Office Action Summary

10/612,787

ISHIWA, MASARU

DETAILED ACTION

FIG. 4

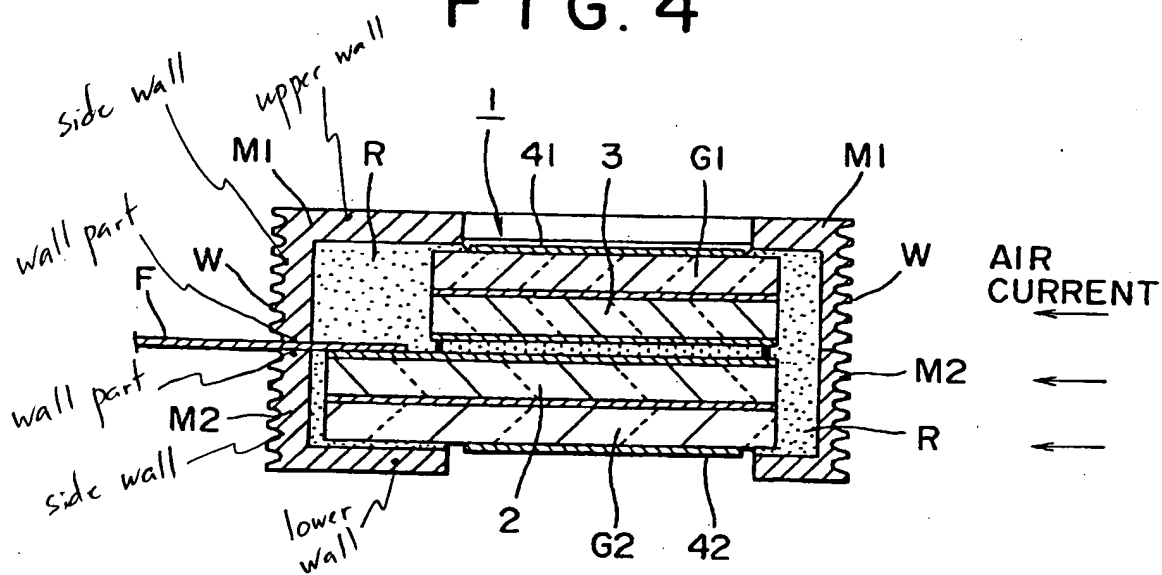
Re claim 1, as shown in Fig. 4 (annotated), Yamanaka discloses a liquid crystal display device comprising:

a liquid crystal panel 1 having a pair of substrates 2 and 3 and a liquid crystal LC interposed therebetween (see also Fig. 1),

a flexible cable F connected to one of the substrates (2);

wherein said unit cover comprises a lower cover M2 and an upper cover M1 coupled to each other,

said lower cover M2 having a lower wall (bottom portion) supporting said one of the substrates (2), a side wall (vertical portion) provided on one side of said lower wall, and a wall part (top portion) bent from said side wall,

the upper cover M1 having an upper wall (top portion), a side wall (vertical portion) provided on one side of said upper wall, and a wall part (bottom portion) bent from said side wall and opposed to the wall part of said lower cover M2, and

wherein said flexible cable F extends between said wall part of the lower cover M2 and said wall part of the upper cover M1 from the inside to the outside of said unit cover, said flexible cable F extending substantially parallel to said one of the substrates (2 or 3) where said flexible cable F is bonded to said one of the substrates (2) and between the wall part of the lower cover M2 and said wall part of the upper cover M1, and is interposed between, and held by, said wall part of the lower cover M2 and said wall part of the upper cover M1 (col. 6, lines 45-56).

Re claim 2, said flexible cable F is bonded to said wall part of the lower cover M2 as shown in Fig. 4.

Re claim 4, as shown in Fig. 4, the lower wall of the lower cover M2 has an opening portion at the bottom for receiving the liquid crystal panel 1; accordingly, the display unit can be removed (peeled off) from the opening portion of the lower cover.
